TECHNICAL NOTE

Job Name: Waterfront Square, Norman Road, Reading
Job No: 332610561
Note No: TN002
Date: December 2024
Prepared By: Richard Fisher
Subject: **CLARIFICATION TO ADDRESS ENVIRONMENT AGENCY (EA) COMMENTS**
EA LETTER DATED 12TH NOVEMBER 2024, EA REF: WA/2024/131767/01-L01
READING BOROUGH COUNCIL (RBC) PLANNING REFERENCE PL/24/0958

Figure 1: View east along southern site boundary

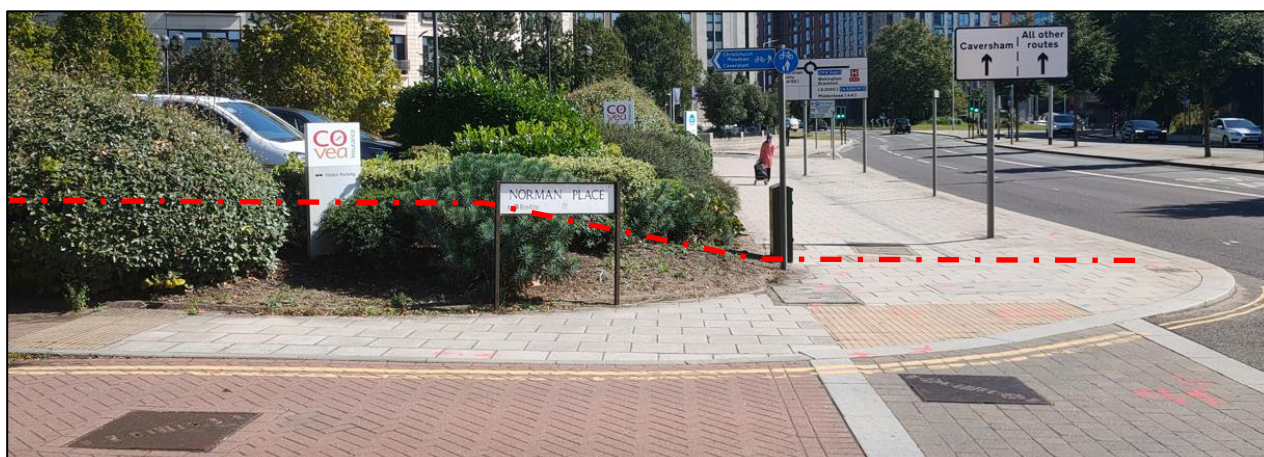
“The proposed 60 m wall to the south of the site bordering Vastern Road is within the 1% annual exceedance probability (AEP) plus 35% climate change allowance design flood extent. The flood plain level is 38.18 mAOD (above ordnance datum) and 1% AEP + 35% depth of flooding would be approximately 300 mm. The wall has the potential to impede flood flow and increase the hazard to the road and increase flood risk offsite.”

The reference climate change flood level on this side of the site is 38.2m AOD. As shown indicatively on **Figure 1**, this boundary of the site rises from the Vastern Road footpath level (37.9m AOD) up a vegetated bank to the existing car park level at 38.4m AOD. As such, the floodplain extends partly up this vegetated bank but does not spill into the raised car park area, from a maximum depth of 300mm on the footpath up to zero.

Figure 2: 1 in 100 Annual Probability +35% Climate Change Floodplain – Southern Site Boundary

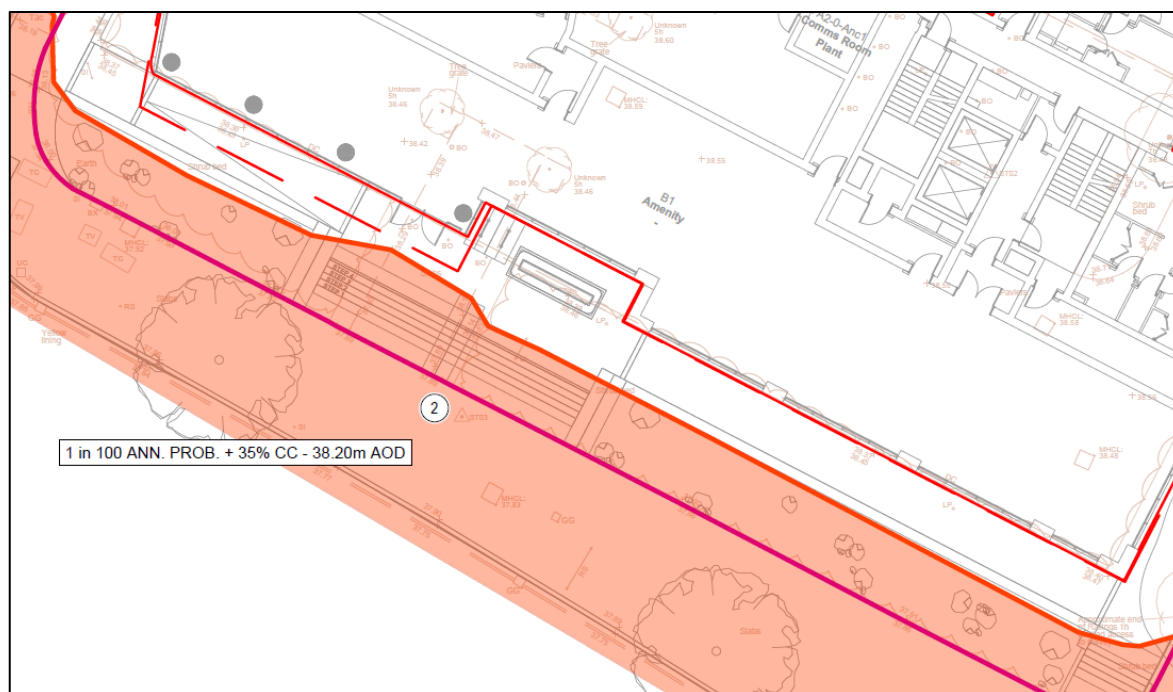
“The applicant should consider either demonstrating that the wall will not increase risk offsite or look at alternative options which would not impede the flow of flood water. The applicant could consider breaks in the wall, for example, every 5 m of length with 1 m openings.”

Figure 2 confirms that the proposed wall running along the southern part of the site is just outside the floodplain. The only elements just within the floodplain are (i) the main site entrance steps, (ii) the associated sidewalls, and (iii) the smaller set of steps in the south-east corner of the site.

The proposed steps along this boundary will have a negligible impact on floodplain storage; they step up from the existing Vastern Road ground level, up to the same approximate level as the existing car park, along the same approximate gradient/profile as the existing earth bank.

The sidewalls of the main steps would have the potential to cause a small obstruction to the periphery of the floodplain, and cause a small loss in floodplain storage; a plan area of 12m², over an average depth of 150mm, results in a loss of 1.8m³. This is clearly negligible, and ignores the overall significant enhancement to floodplain capacity provided by the site.

As noted above, it is evident the only impact would be from the limited area of steps (and steps sidewall) encroaching into the edge of the climate change floodplain, this impact is negligible and is significantly compensated for by the proposed enhancements on the north side of the site.

The base of the steps side walls within the floodplain could be designed to be open if this remained a concern to the EA despite the above evidence (and secured through a suitably worded planning condition).

Figure 4: 1 in 100 Annual Probability Event – Flood Hazard

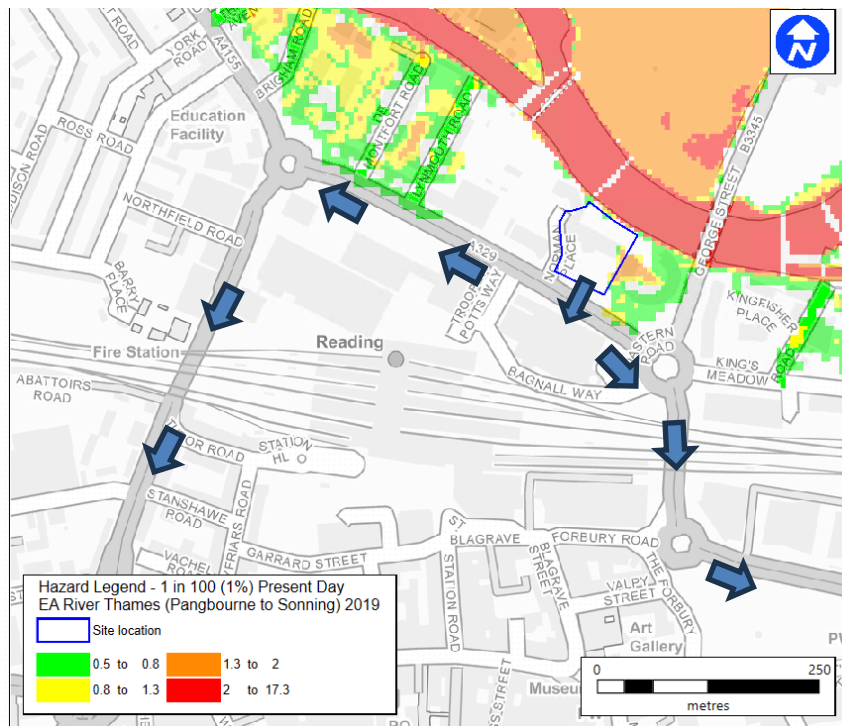
“We have considered the findings of the flood risk assessment in relation to the likely duration, depths, velocities and flood hazard rating against the design flood for the proposal. The applicant has discussed the hazard rating, mentioning very low hazard for the 1% AEP flood, but has not provided a plan showing safe access and escape routes.

This confirms that a continuous dry access route was available to occupants of the development in events up to and including the present day 1 in 100 annual probability flood. The optimal routes are south towards the town centre, either west along Vastern Road and south on Caversham Road, or east on Vastern Road, under the railway line and south-east via Forbury Road/Forbury Gardens.

Figure 7.1 provided the Flood Hazard mapping for this event but this is replicated in **Figure 4** below with arrows to denote access routes as requested.

Figure 5: 1 in 100 Annual Probability +35% Climate Change Event – Flood Hazard

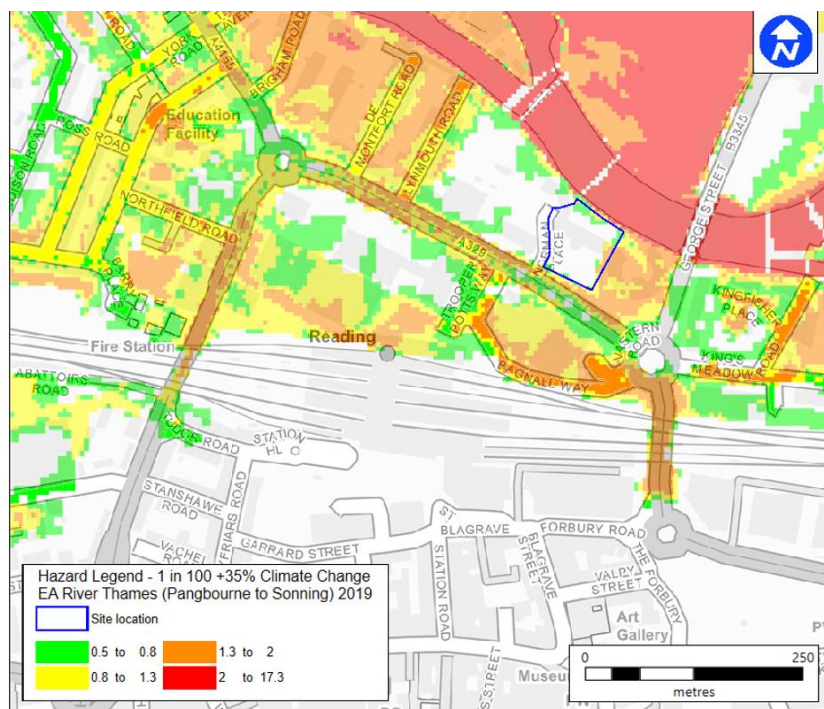
The FRA does not say what the hazard is for the 1% AEP with an allowance for climate change. However, the applicant has suggested a 'Flood Management and Evacuation Plan' is produced.

The flood hazard rating from the Thames (Pangbourne to Sonning) 2019 model indicates during the design flood there will be a danger to most people (e.g. there will be danger of loss of life for the general public).”

FRA Figure 7-2 denoted the flood hazard at the peak of the 1 in 100 annual probability +35% climate change event. As detailed in the FRA, this confirms that there is not a safe ('very low hazard') pedestrian route out of the site at the peak of this event due to the new flood flow routes across the area and along Vastern Road, resulting in a 'danger for some' on the adjacent footpath – see **Figure 5**.

As noted in the FRA, in accordance with the Reading SFRA guidance a Flood Management and Evacuation Plan will be produced for the development to ensure that residents are provided with sufficient advance warning to evacuate the site prior to the access routes becoming blocked.

This can be secured through planning condition, and is on the basis that the River Thames is a slow-responding catchment and there has been widespread public awareness of prior flood events in the area several days before the area was affected, and there would be visual signs of wider flooding and the slowing rising floodwater from the site for a period of multiple days before any access routes are compromised.
